19.7-03

TECHNICAL BULLETIN

Knocking from Front Suspension – Shock Absorber Mounting – Repair Procedure

MODEL 1995-96 MY
Sedan Range
VIN
720001-ON

ILLUSTRATION 1

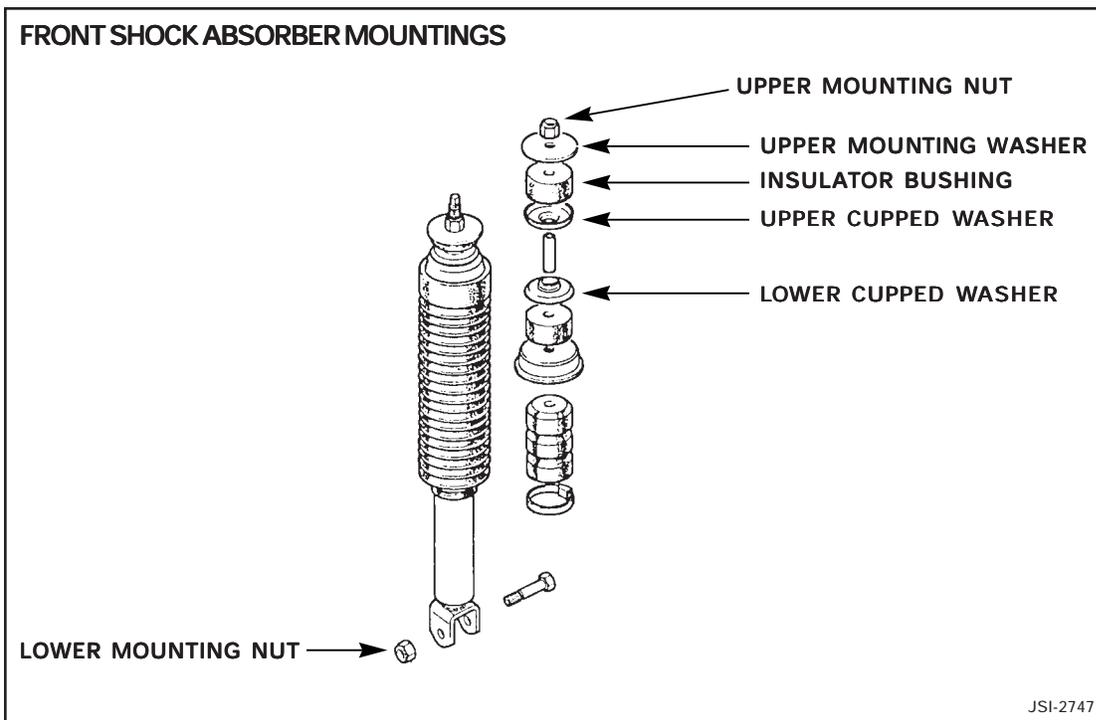
2. Check that the shock absorber upper cupped washer (Illustration 1) is fully seated against the inner fender panel in the engine compartment.
3. Remove the upper mounting nut (illustration 1) and remove the upper mounting washer and insulator bushing.
4. Inspect the cupped washer. If the washer is distorted or damaged in any way, install a new cup washer (part no. CBC 5431). Reassemble the bushing and cup washer, ensuring that the cup washer is correctly seated against the body. Always install a new nut (part no. JZN 100013) and torque to 26 lb. ft. (35 Nm).
5. Repeat steps 1-4 on the opposite side of the vehicle.
6. Reinstall components removed in step 1.

ILLUSTRATION 2

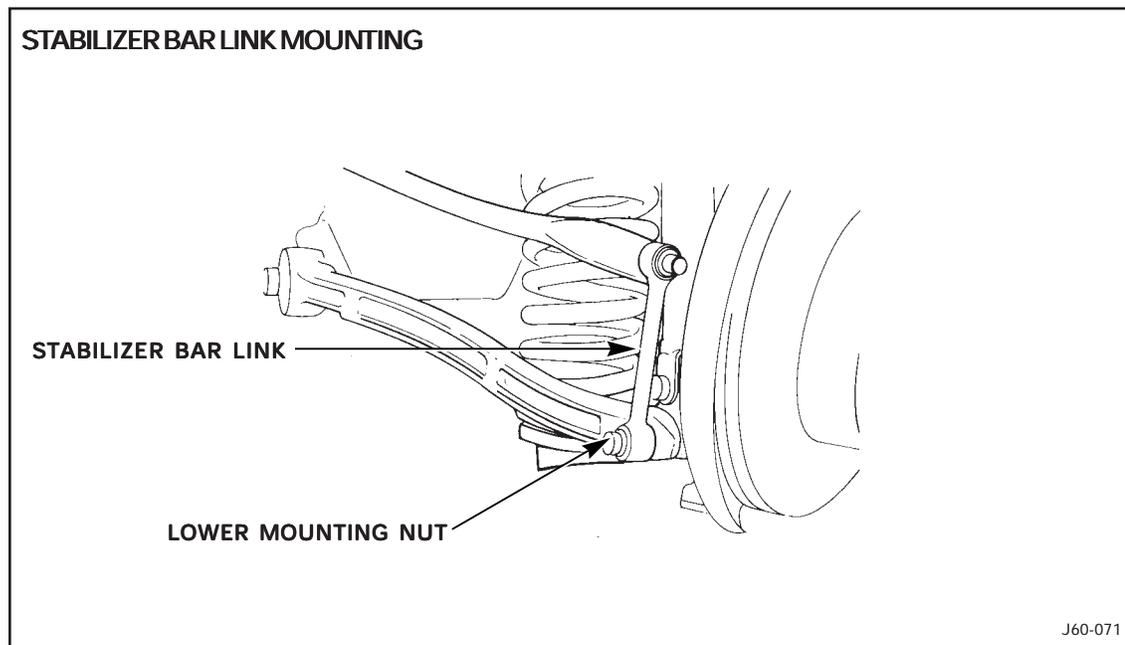
1. After performing the above inspection, raise the vehicle on a lift so the front suspension hangs fully extended.
2. Remove the mounting nut (Illustration 2) from the lower mounting of the stabilizer bar link. Discard the nut. Move the link aside to allow access to the lower mounting of the shock absorber.
3. Remove and discard the existing lower mounting nut (Illustration 1) from the lower mounting bolt of each shock absorber.
4. Install a new mounting nut (part no. JZN 100013) and torque to 51.6 lb. ft. (70 Nm).

5. Reinstall the stabilizer bar link using a new nut (part no. JZN 100013) and torque to 70 lb. ft. (95 Nm).
6. Repeat steps 1-5 on the opposite side of the vehicle.
